**Staff Report to the
Southeast Town Design Review Committee
June 9, 2016**

**MPL2016-00020
ITEM #1**

PIONEERS HOLIDAY INN EXPRESS

PROPOSED SITE PLAN

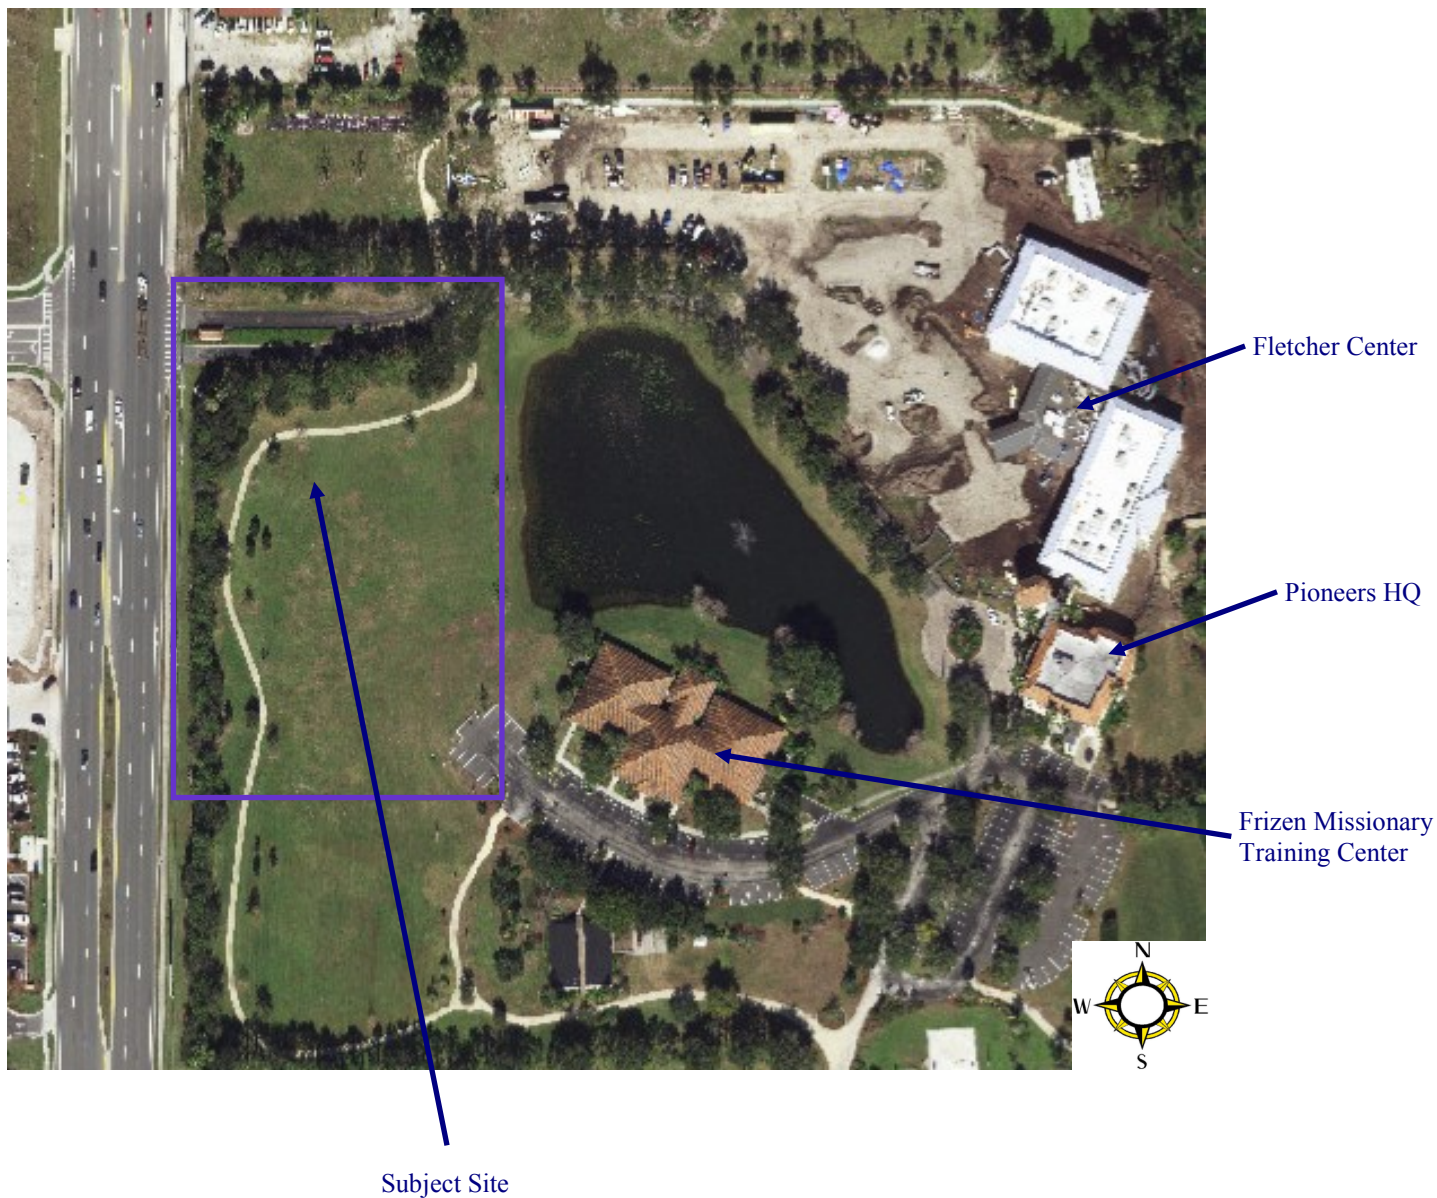
The Pioneers PD specifies a maximum ISR of 0.85 for properties designated as Village Center. The proposed ISR for this development is 0.623. The applicant has submitted a site plan (page 7) that shows stormwater managed by a pond directly east of the subject site.

The site plan shows a walkway along the north, east, and west sides of the building site perimeter. A publicly accessible walkway leads directly from Narcoossee Road to the establishment's front door, crossing a vehicular travelway in the process.

Primary automobile access is on the North-South road at two locations on the east side of the building (north and south). Automobiles enter from the North-South road and circle around to the west side of the building where the main entrance is.

There is an existing sign located within the median of William Carey Drive. City code requires for this sign to be removed in order to preserve site lines for pedestrians and automobile drivers. The site plan shows a new sign location at the northwest corner of the subject property. This sign is intended to serve as signage for the Holiday Inn Express and the Pioneers campus. A complete signage package will be required for appearance review at the time of final site plan permitting.

LANDSCAPING PLAN

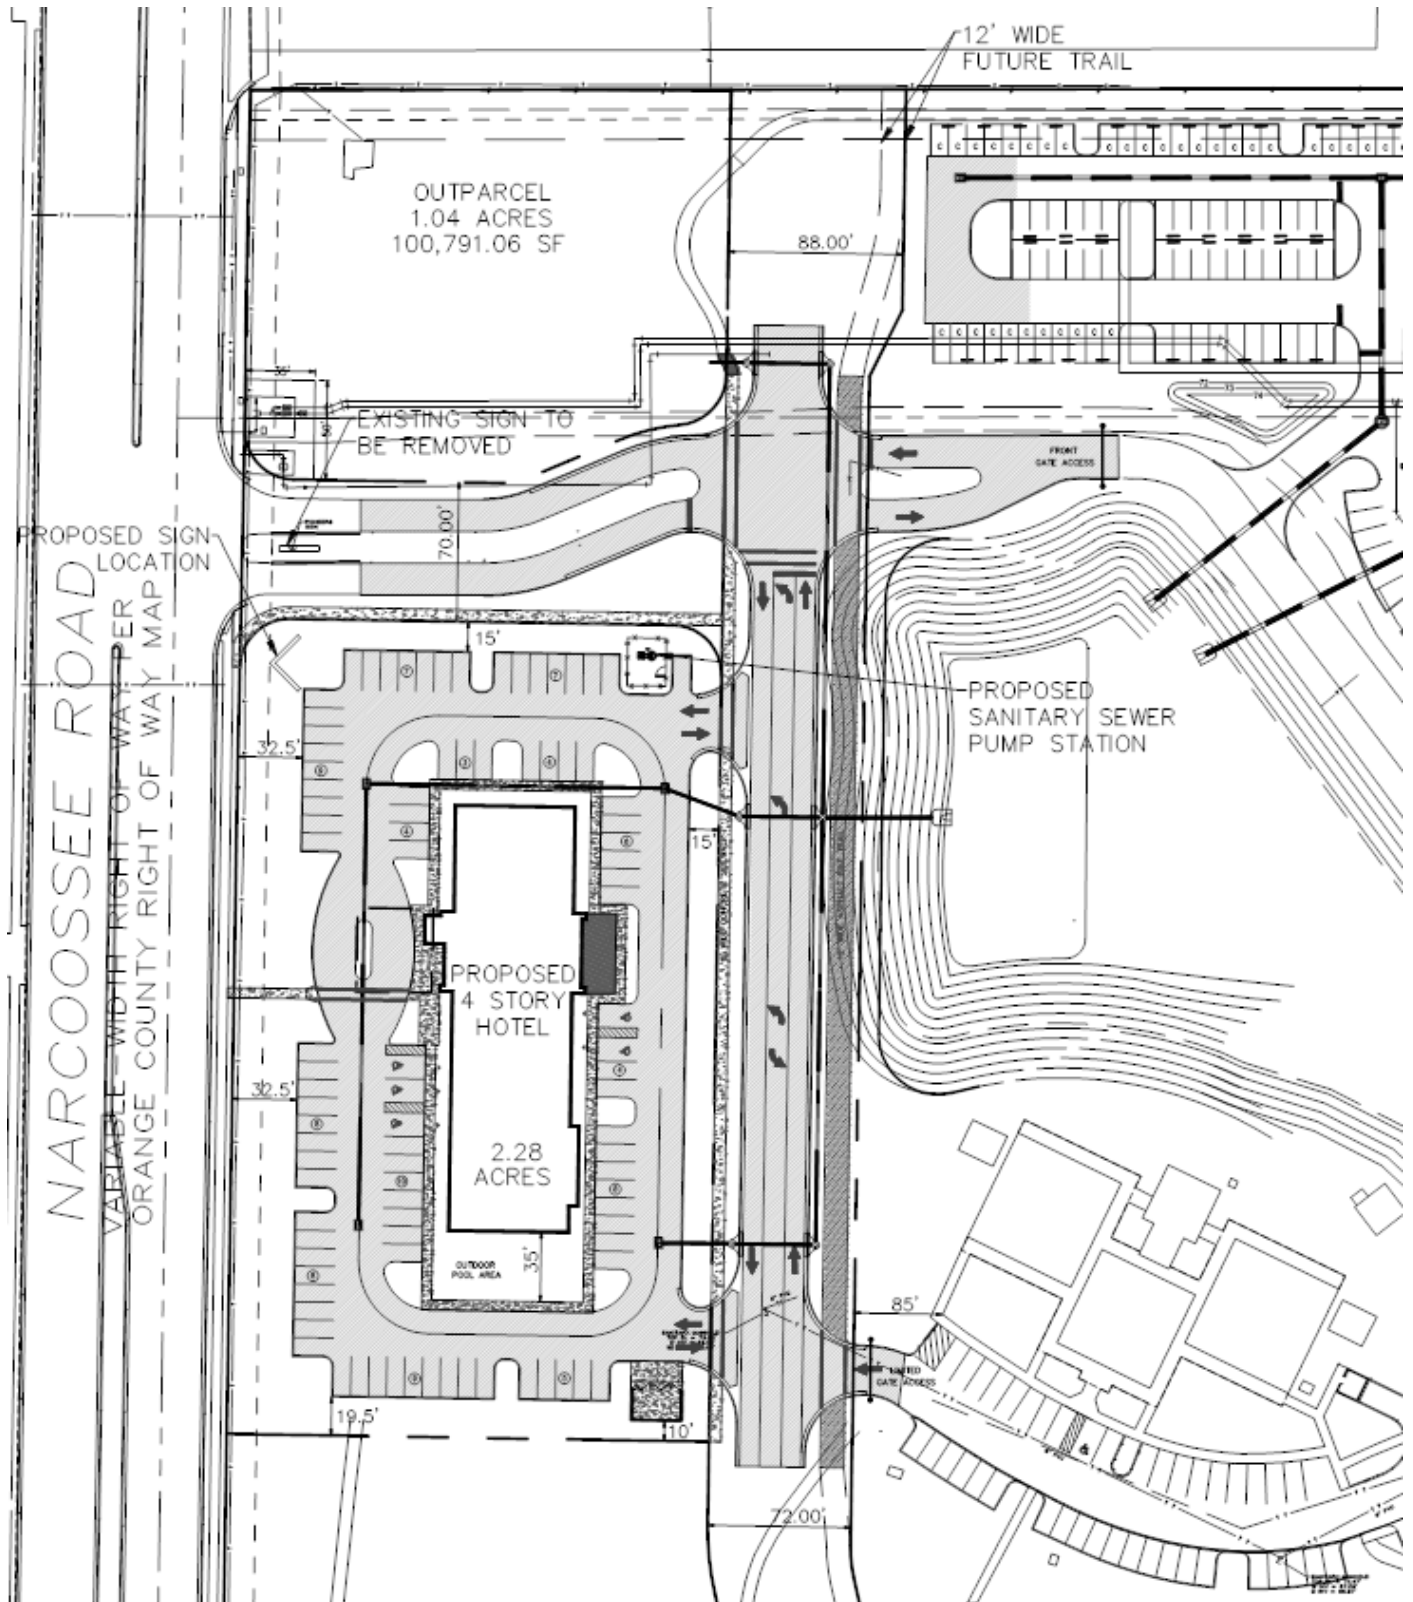
The applicant has submitted a landscaping plan (page 8) with this application, including a plant list (page 9) which meets conventional LDC standards. Section 68.324 emphasizes that broadleaf trees should predominate in parking areas.

CROSS SECTION OF NORTH-SOUTH ROAD

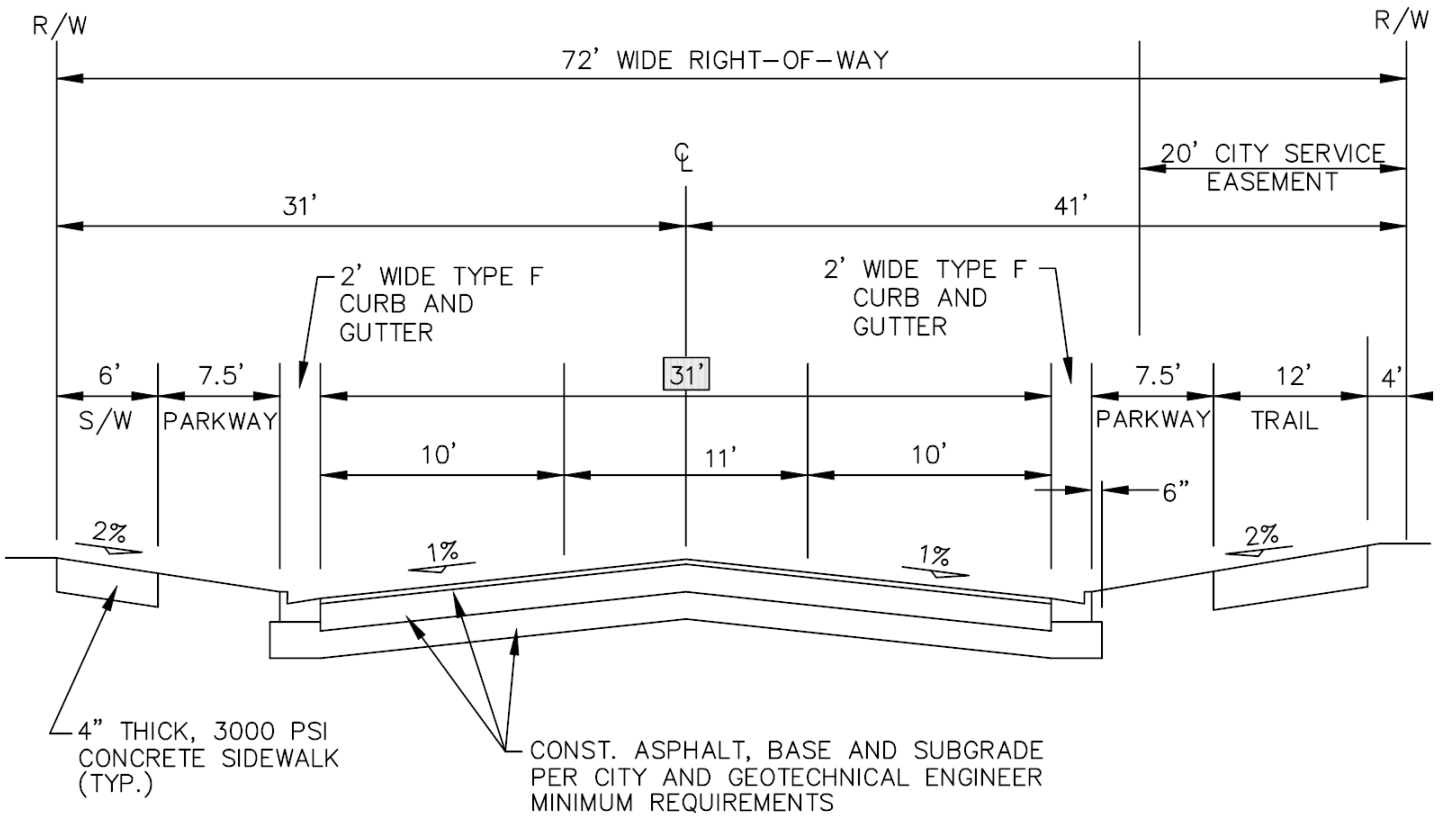
Typical two-way arterial roads in Village Center include parking, bicycle lanes, sidewalks, and at least 67 feet of right-of-way. Because there is already ample existing parking, street parking spots on the North-South road are not required. Plans show a 12 foot wide multi-use trail along the east side of the North-South road and a 6 foot wide sidewalk on the west. The total right-of-way equals 72 feet (see page 10 for North-South road cross section).

FRONT (WEST) AND REAR (EAST) ELEVATIONS

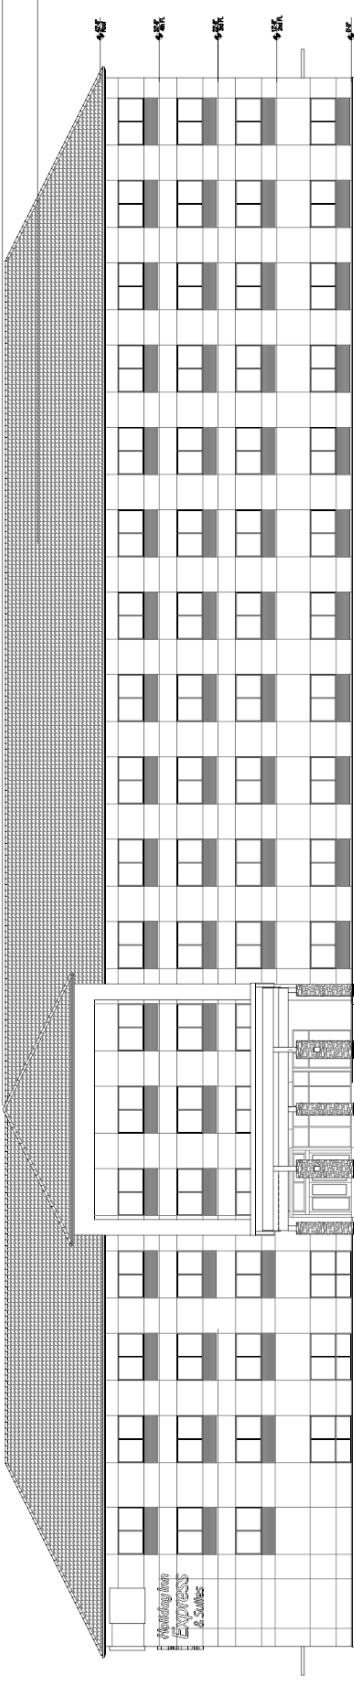
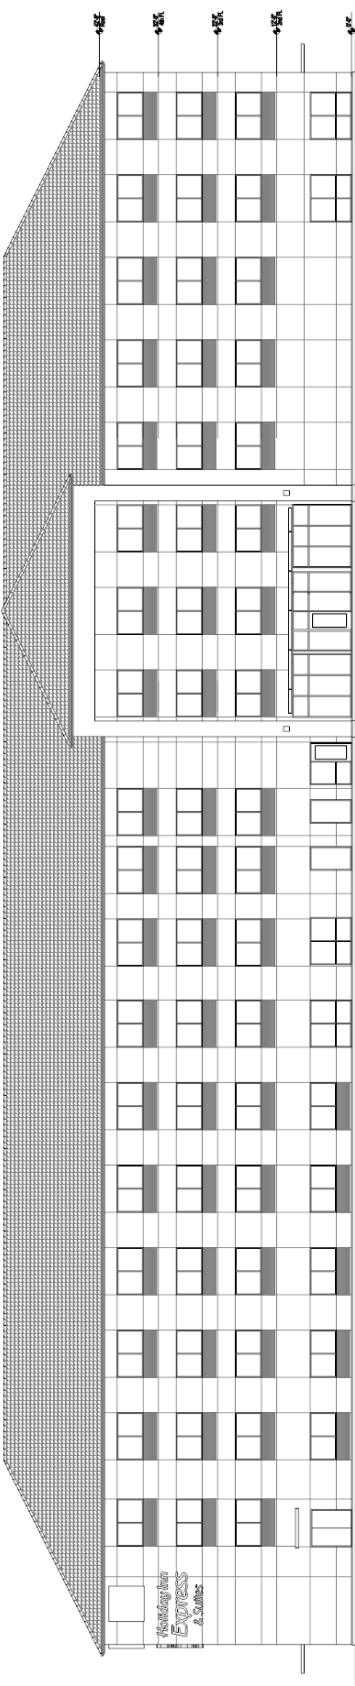
In the Southeast Sector Plan, height is limited by the number of stories, not the overall height to provide variety to the skyline in the mixed use centers. Commercial buildings shall have no more than 25 foot floor to floor heights. According to the Pioneers PD, Parcel A allows for a height limit of four (4) stories. The proposed elevations on pages 11 and 12 show a maximum height of four (4) stories totaling 60 feet.
